H2Teesside Project

The H2 Teesside Order

Document Reference: 8.51 The Applicant's Environmental Position Statement (Deadline 8)

Applicant: H2 Teesside Ltd

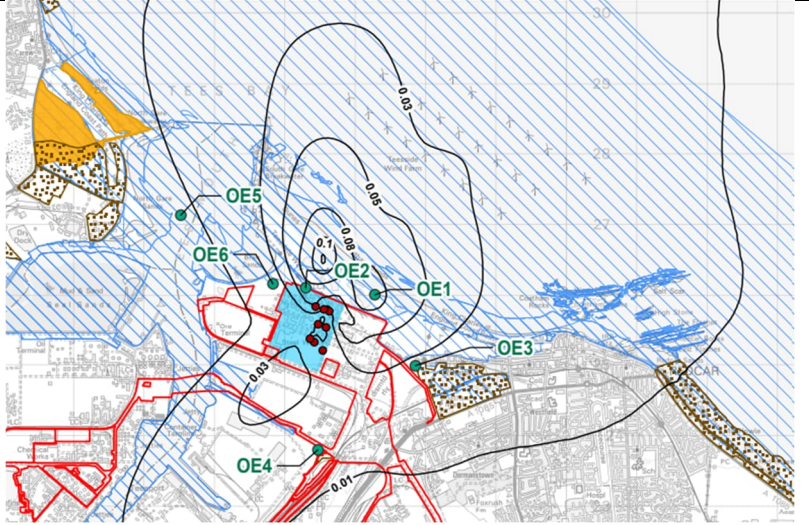
| REF NO. | NES DEADLINE 7A RESPONSE | APPLICANT'S DEADLINE 8 RESPONSE |
|---------------------------------------------------------------------------------------------------------------------|--------------------------------------------------------------------------------------------------------------------------------------------------------------------------------------------------------------------------------------------------------------------------------------------------------------------------------------------------------------------------------------------------------------------------------------------------------------------------------------------------------------------------------------------------------------------------------------------------------------------------------------------------------------------------------------------------------------------------------------------------------------------------------|--------------------------------------------------------------------------------------------------------------------------------------------------------------------------------------------------------------------------------------------------------------------------------------------------------------------------------------------------------------------------------------------------------------------------------------------------------------------------------------------------------------------------------------------------------------------------------------------------------------------------------------------------------------------------------------------------------------------------------------------|
| NE31 Natural England's comments on 'H2 Teesside report to Inform Assessment of Air Quality Impacts on Teessmouth | <u>Overall comments</u> Natural England provided comments on this to the Applicant on 14/02/25. Whilst we accept no AEOL on the Teessmouth and Cleveland Coast SPA, we do not agree that the assessment excludes harm from air pollution impacts on the Teessmouth and Cleveland Coast SSSI due to the impact on the vegetated designated features cumulatively with other plans and project. The project alone would add 1.1% of the critical load for n-dep (0.11kgN/ha/yr) and 10.1% (1kgN/ha/yr) in-combination. At present no mitigation | See Annex B which deals with this issue in the round. To answer the ExA's question shortly, however, the key point is that the Parties will not be 'resolving' this matter in a DCO context. The Applicant would note that nitrogen deposition as a result of the Proposed Development represents a very small contribution (1.1%) to an overall cumulative level of nitrogen deposition (10.1%) of the 'lower critical load' of 10kgN/ha/yr and that this contribution only occurs over a very small area of the SSSI relative to the overall designated area (the area |

| REF NO. | NES DEADLINE 7A RESPONSE | APPLICANT'S DEADLINE 8 RESPONSE |
|--------------------------------------------------------------------------------|--------------------------------------------------------------------------------------------------------------------------------------------------------------------------------------------------------------------------------------------------------------------------------------------------------------------------------------------------------------------------------------------------------------------------------------------------------------------------------------------------------------------------------------------------------------------------------------------------------------------------------------------------------------------------------------------------------------------------------------------------------------------------------|----------------------------------------------------------------------------------------------------------------------------------------------------------------------------------------------------------------------------------------------------------------------------------------------------------------------------------------------------------------------------------------------------------------------------------------------------------------------------------------------------------------------------------------------------------------------------------------------------------------------------------------------------------------------------------------------------------------------------------------------------------------------------------------------------------------------------------------------------------------------------------------------------------------------------------------------------------------------------------------------------------------------------------------------------------------------------------------------------------------------------------------------------------------------------------------------------------------------------------------------------------------------------|
| <p>and Cleveland Coast SSSI DRAFT'</p> <p>Also ExA Rule 17 Request Item 11</p> | <p>has been secured for this impact, and the project has not provided evidence that harm on the SSSI can be ruled out.</p> <p>It is our opinion that the project requires mitigation for its cumulative effect with regards to N-deposition on Teesmouth and Cleaveland Coast SSSI. We previously provided advice on potential mitigation options by email to the Applicant on 18/12/24. We note that in the H2 Teesside report to Inform Assessment of Air Quality Impacts on Teesmouth and Cleveland Coast SSSI DRAFT' the Applicant suggests in Paragraph 3.1.9 that strategic action could be taken to address these issues, however such an approach is not yet established and therefore cannot at present be used to deliver or secure mitigation for this project.</p> | <p>within the 0.1 contour shown on CR1-037 – this has been inserted below for ease of reference). The perceptible contribution of H2Teesside (i.e. the area subject to an increase of 1% of the critical load or above due to the scheme) only affects a very small amount of the SSSI: 0.5%. The 'lower critical load' is a theoretical level at which nitrogen deposition could begin to have an effect on the ecology of the SSSI. It is clear that the SSSI developed and was designated during a period when nitrogen deposition rates were much higher. These have declined significantly in recent years and are likely to continue to decline further with the uptake of electric vehicles and the transition of industries across Teesside. Finally, focusing on this one theoretical pressure that affects a very limited area of the SSSI doesn't take into account other more significant pressures on the SSSI that already exist, such as dog walking and recreational use. As such the Applicant maintains that it is not reasonable for Natural England to object to development in the area on the basis of a highly theoretical, potential future impact to the SSSI from the Proposed Development's de-minimus contribution to nitrogen deposition.</p> |

| REF NO. | NES DEADLINE 7A RESPONSE | APPLICANT'S DEADLINE 8 RESPONSE |
|---------|--------------------------|------------------------------------------------------------------------------------------------------------------------------------------------------------------------------------------------------------------------------------------------------------------------------------------------------------------------------------------------------------------------------------------------------------------------------------------------------------------------------------------------------------------------------------------------------------------------------------------------------------------------------------------------------------------------------------------------------------------------------|
| | |  <p data-bbox="1272 884 2078 1273">That notwithstanding, the Applicant is voluntarily happy to work with NE on strategic mitigation approaches, but for the reasons given above and in Annex B its position is that it should not in fact be required to mitigate. If the ExA or Secretary of State disagrees with this, then the Applicant 'falls back' to the National Policy Statement position, and considers that the public benefit of the Proposed Development, that is Critical National Priority Infrastructure, outweighs any 'unmitigated' 'impact' that might be considered to be assignable to the Proposed Development.</p> |
